Memorandum

Subject: Report for Travel to Katahdin Woods and Water National Monument (KAWW)

Photo 4: Obstructed Culvert on Loop Road

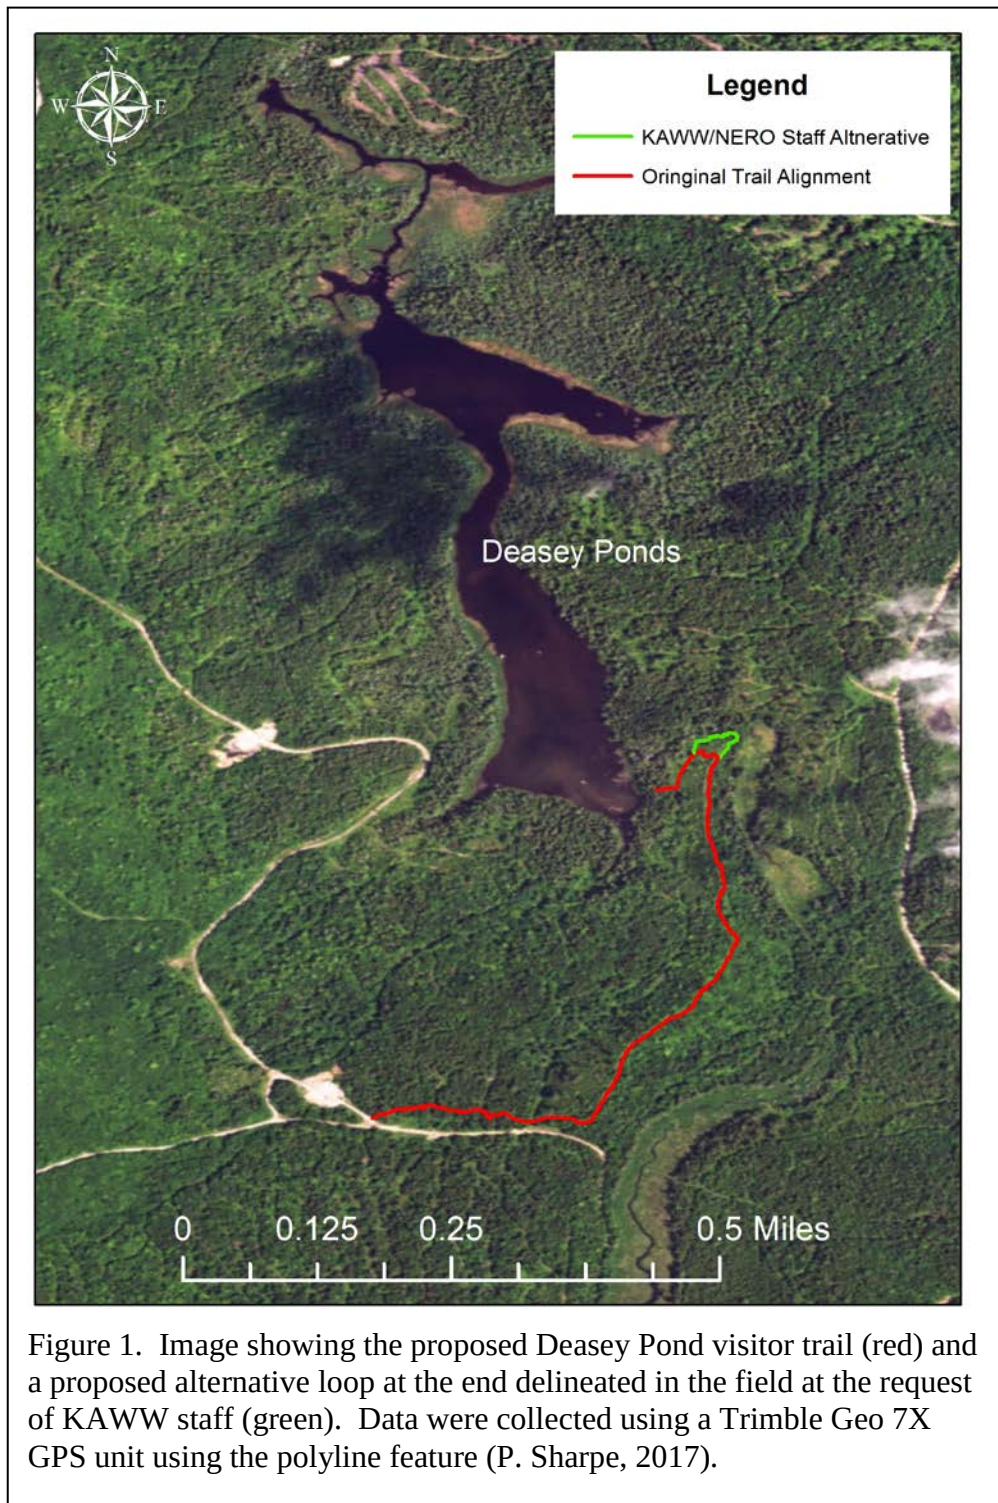
Several culverts have been identified as needing repair or maintenance. These structures present road hazards as portions of the tops of some of these culverts are significantly above road grade, they were not properly sized when initially installed, or have been obstructed and are impeding flow.

While some of these culverts do not necessarily present a natural resources concern, improperly sized or plugged culverts may result in longer-term issues with flooding and erosion and sedimentation of roads which will adversely impact water resources. Many culverts may need compliance as they are associated with drainages that have been stocked with Atlantic salmon as part of a species restoration program.

2. Improperly sized and installed culverts should be replaced or reinstalled at the proper stream gradient elevation and ensuring that they are appropriately sized for streamflow and backfilled with sufficient cover to prevent humps in the road, and blocked culverts cleared of all obstructions. Culvert replacement should consider future climate scenarios which may include more intense periods of rainfall that would require larger drainage capacity. When possible, the culverts in fish habitat should be replaced with open-bottomed culverts or small bridges.

Figure 2. Image showing the proposed realignment of the Twin Ponds visitor trail (light blue). This route will avoid wetland encroachments while still providing visitor access to the pond. Data were collected using a Trimble Geo 7X GPS unit using the polyline feature (P. Sharpe, 2017).

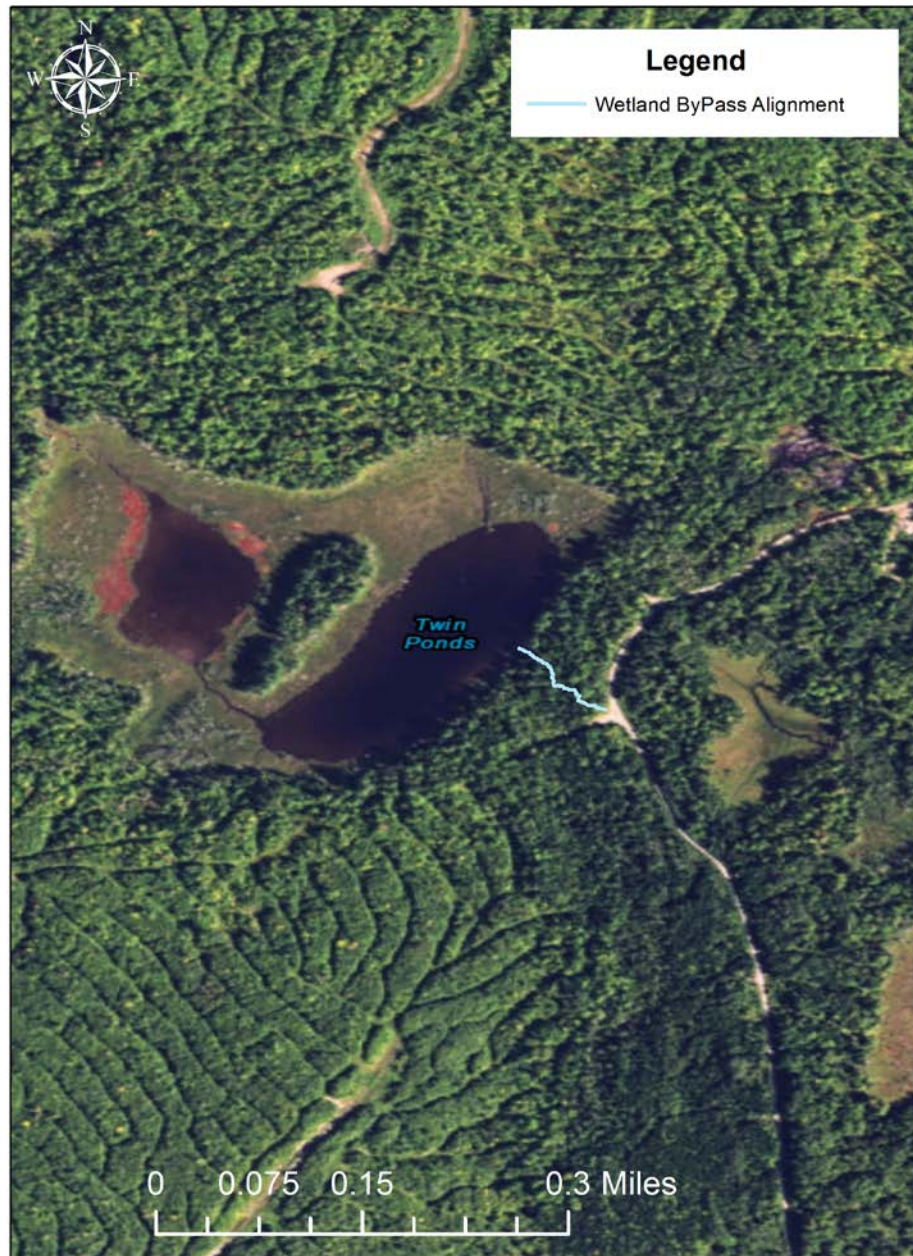
The trail at Twin Ponds runs through a wetland area that has had some corduroy placed in it in an attempt to reduce impacts and facilitate a dry crossing on foot. KAWW and NERO staff identified an alternative trail alignment (see Figure 2) which will bypass the wetland entirely thereby eliminating the existing wetland impact and still allow for visitor access to the site.

1. At Deasey Ponds the proposed trail appears to have no obvious signs of water resource impacts. The KAWW staff directed realignment (green line - Figure 1) should be considered the preferred route to traverse around the southeast hill at the Ponds.
2. At Twin Ponds the proposed trail alignment shown in blue Figure 2 should be utilized as the preferred alternative to the existing alignment as it will eliminate current wetland impacts.
